**Society of Broadcast Engineers, Inc.**

**ET Docket 95-18  
Allocation of 2 GHz Spectrum for  
Use by the Mobile-Satellite Service**

**Petition for Partial Reconsideration of the  
Second R&O and Second MO&O**

September 5, 2000

Example of Split-Channel Operation  
ENG Channel A3

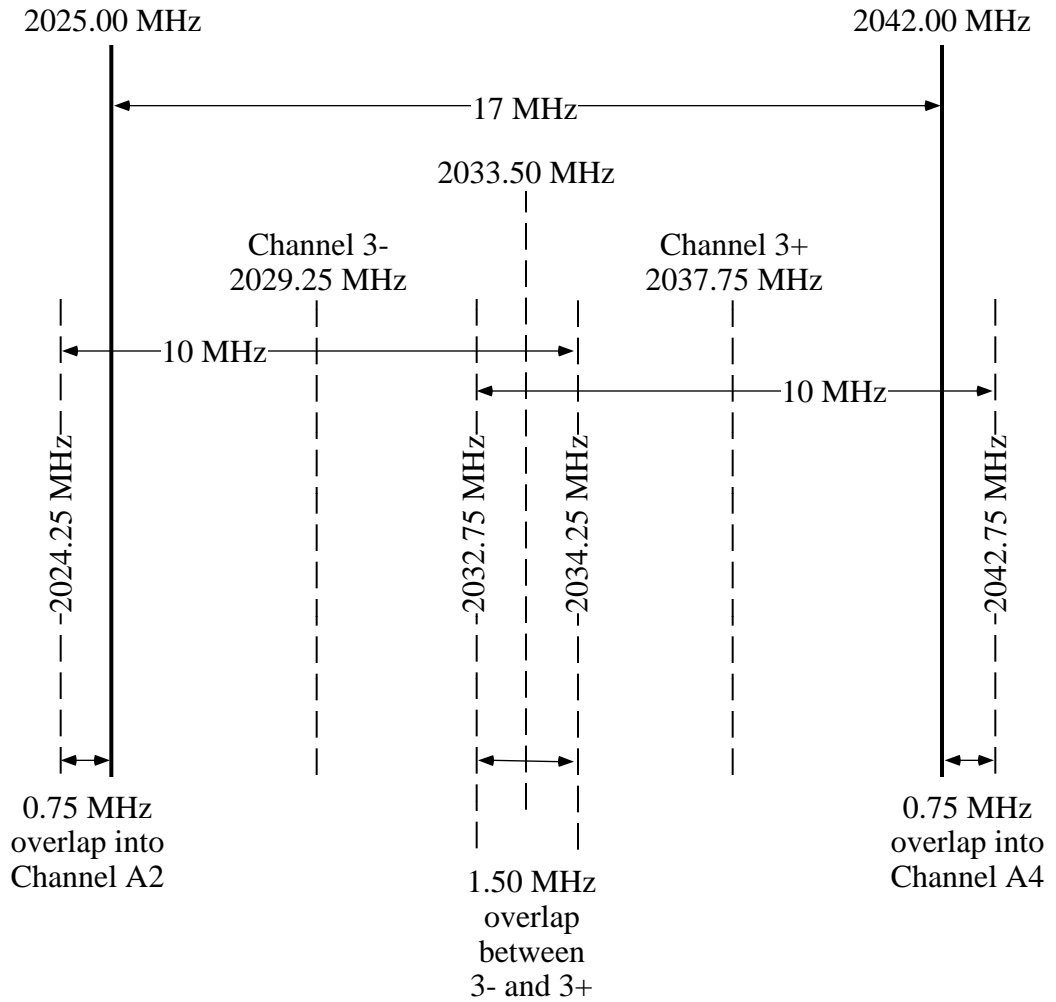
4. If a six 17-MHz wide channel Phase I option is selected, then split-channel operation using twelve 10-MHz wide channels, with 750-kHz overlaps with the lower and upper adjacent channels, and with a 1.5-MHz “in-channel” overlap with each other, is feasible; this option is shown in the attached Figure 2, and is specifically permitted by Paragraph 45 of the Second R&O. Stringent frequency coordination efforts must be taken to ensure a better than zero dB desired-to-undesired (“D/U”) received signal ratio between the “desired split” and both undesired adjacent splits, in all cases. As has been proven in the Los Angeles market, where the demand for ENG spectrum is extreme, techniques including cross polarization and the routine adjustment of each link's equivalent isotropic radiated power (“EIRP”) for the electronic news gathering (“ENG”) paths in question can ensure such conditions. SBE anticipates that this option will be popular and applauds its inclusion in the Second R&O.

Existing v. Phase Two 2 GHz BAS Band Plan  
(Indefinite Adoption Date)  
with a 5-Channel Phase Two Option

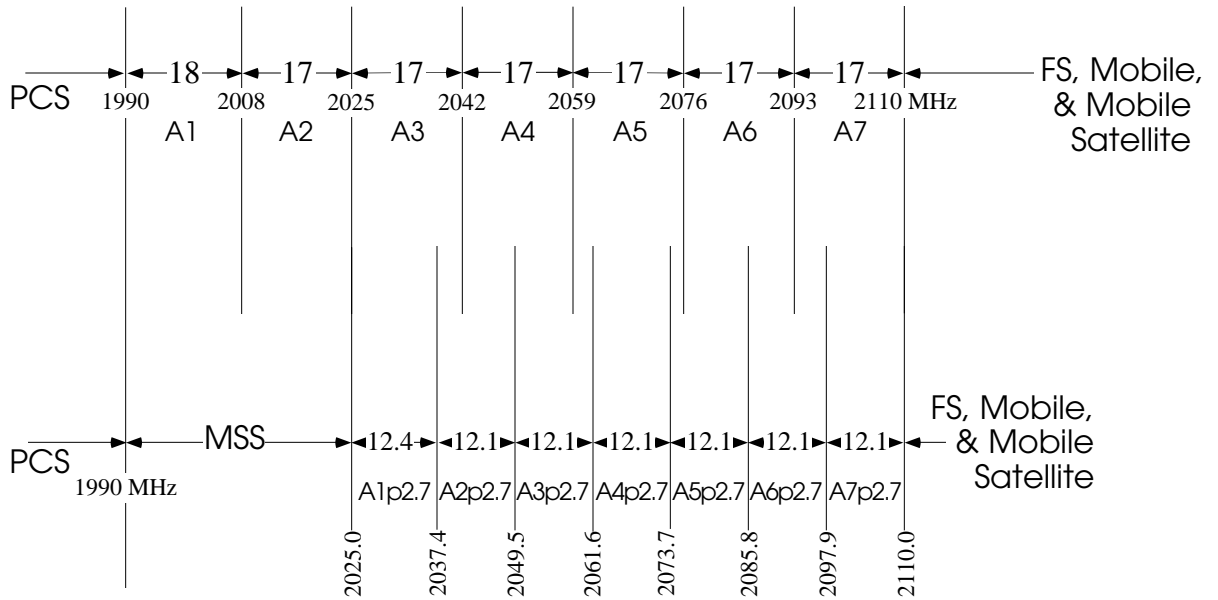
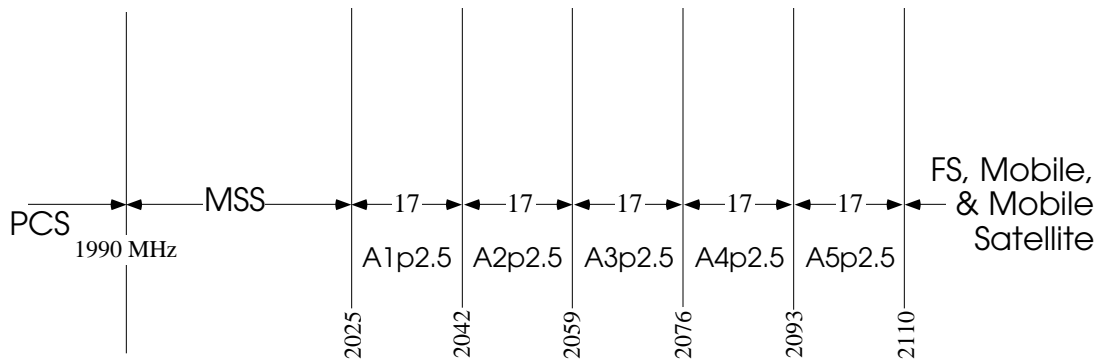
8. As documented by the attached Figure 3, SBE requests that the Commission affirm that broadcasters have the option to select five 17-MHz wide channels under Phase II, rather than seven 12.1 MHz wide channels, so as to at least hold open the possibility of continued use of conventional FM video analog operation under Phase II, especially considering the silence of the Second R&O concerning the future of channelization in markets smaller than 100, thus presumably leaving them as five 17-MHz wide channels permanently. Although it is unclear at this time whether such an option will actually be needed if and when Phase II ever gets

implemented, it is important that this option at least be available. SBE proposes that those channels be identified as “A1p2.5” through “A5p2.5”, as follows:
